REMARKS

AMENDMENTS TO THE DRAWINGS

ANNOTATED MARKED-UP DRAWINGS

~~Fig. 6~~

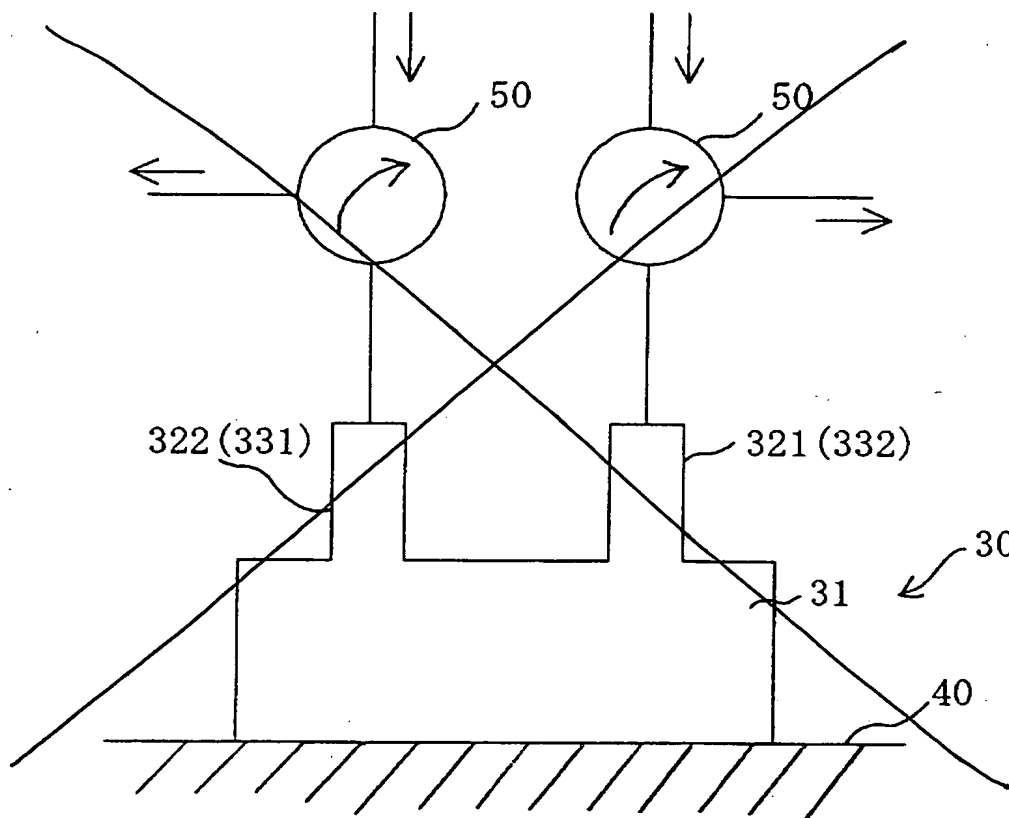
The drawings have been amended as described below. Original FIGURE 6 has been deleted and replaced with a new FIGURE 6. New FIGURE 6 illustrates the subject matter of original FIGURE 6 in an alternative manner which is believed to be more acceptable to the Examiner.

New FIGURE 6A has been added at the request of the Examiner and relates to a logic table for the flip-flop of original FIGURE 6 and new FIGURE 6.

New FIGURE 6B has been added and represents logic gates for the flip-flop of original FIGURE 6 and new FIGURE 6.

ORIGINAL FIGURE 6
REPLACED WITH NEW
FIGURE 6.
